***DOCKET ITEM #12***  
***Development Special Use Permit #2020-0001***  
***Encroachment #2020-0002***  
***Transportation Management Plan SUP #2020-0006***  
***1200 North Henry Street Amendment***

Application	General Data	
<b>Project Name:</b> 1200 North Henry Street Amendment	PC Hearing:	June 2, 2020
	CC Hearing:	June 20, 2020
	If approved, DSUP Expiration:	June 20, 2023 (three years)
	Plan Acreage:	0.8017 (34,921 SF)
<b>Location:</b> 1200 & 1230 North Henry Street	Existing Zone:	CRMU/H: Commercial Residential Mixed Use/High
	Proposed Use:	Mixed Use Residential/Retail/Daycare
	Dwelling Units:	119
	Gross Floor Area:	186,747 SF Total (includes 58,458 SF parking)
	Net Floor Area:	113,493 SF
	Small Area Plan:	Braddock Metro Neighborhood Plan
<b>Applicant:</b> 1200 N. Henry LLC, represented by M. Catharine Puskar, Attorney	Historic District:	N/A
	Green Building:	Compliance with City's 2009 Green Building Policy
<b>Purpose of Application</b>		
Consideration of an amendment request for a Development Special Use Permit with site plan and modifications to construct a multifamily residential building with ground-floor daycare and retail, amending DSUP #2017-00020.

### ***B. Requested A

**Figure 2 – Proposed Revised Building Height Diagram**

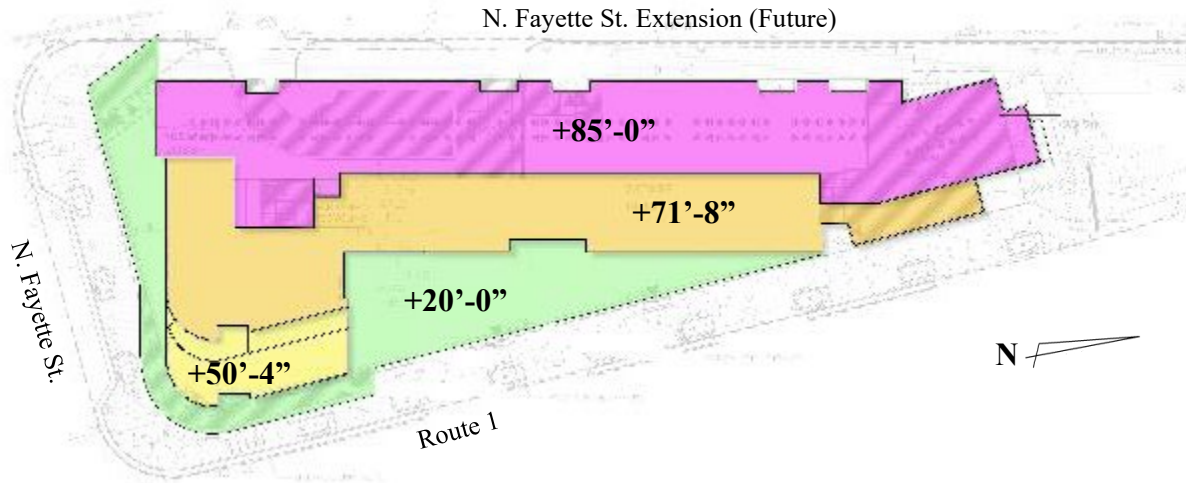
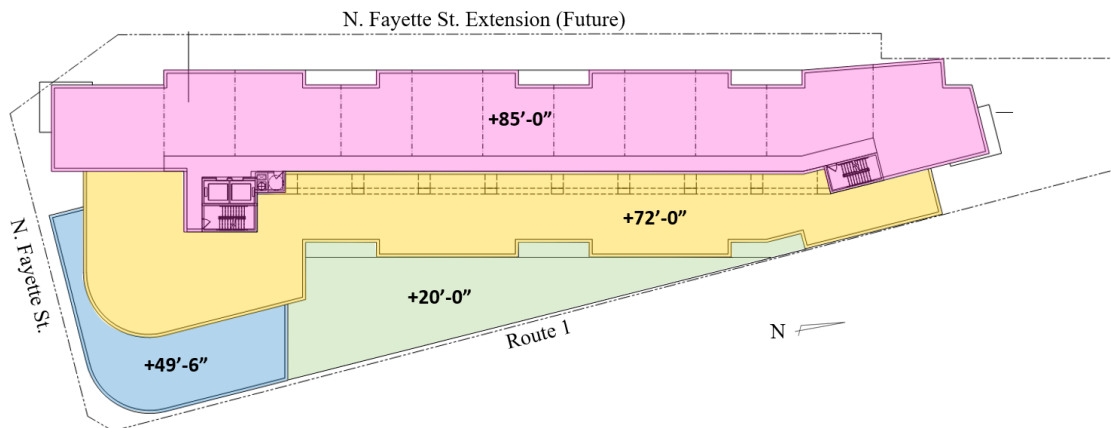
The building has a triangular footprint reflecting the triangular block form, and the building elements and step backs further emphasize this. The west edge of the building follows the future N. Fayette Street extension with an 85-foot high “bar” that spans the majority of the site from north to south. The building height then steps down to the east, measuring approximately 72 feet above grade with an “L” shaped form. Further, a third element, with a pronounced curving corner, steps down to approximately 50 feet. The lowest portion of the building fronts Route 1, measuring 20 feet above grade, and is occupied by retail and the daycare. A rooftop amenity terrace is proposed above this element. The diagrams below (Figure 1 and Figure 2) illustrate the original building footprint and heights and the proposed revised footprint and heights.

*Proposed Site Plan – DSUP #2020-0001*

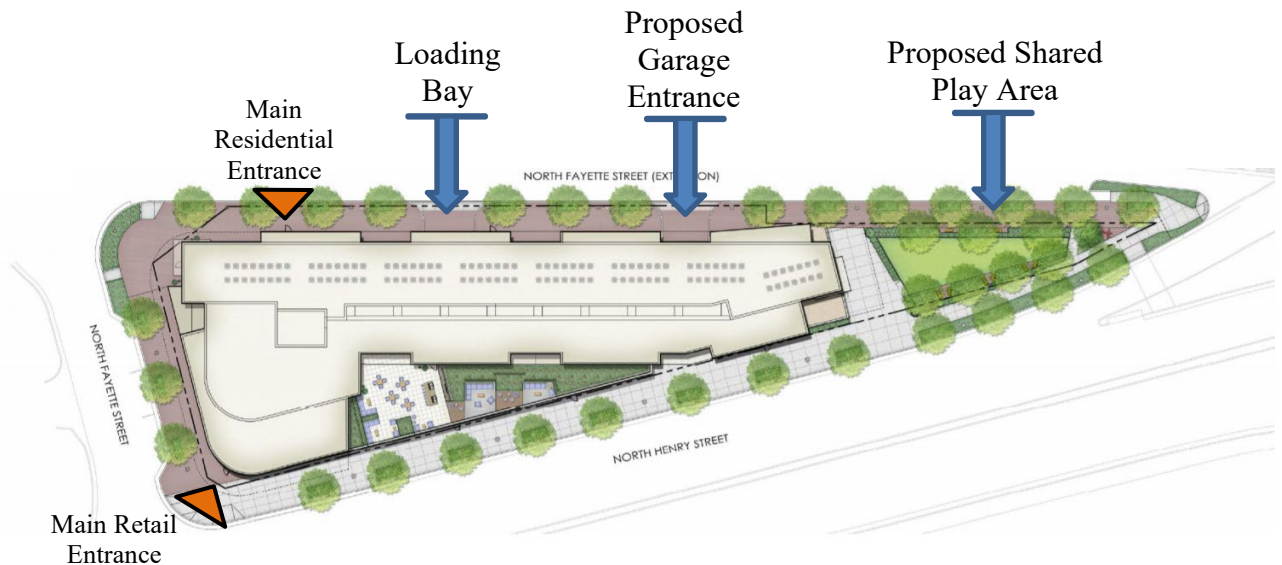
Due to the proposed first level layout and garage entrance changes, the applicant has had to revise the streetscape along the N. Fayette Street extension. The street trees are proposed to meet the 30-foot spacing requirement and will enhance the landscaping and shared use play space at the northern end of the property. Although the applicant is showing brick sidewalks on N. Fayette Street and N. Fayette Street extension, during extensive discussion by the Planning Commission and City Council related to the application for an age-restricted senior multifamily building at 1112 First Street, there was expressed a strong preference for a hybrid sidewalk design with concrete and brick. The hybrid sidewalk design retains the higher finish quality envisioned in the Braddock Metro Neighborhood Plan for designated Walking Streets while also providing for a safer pedestrian realm. Based upon this, staff is recommending that the hybrid sidewalk design be installed (Condition #2).
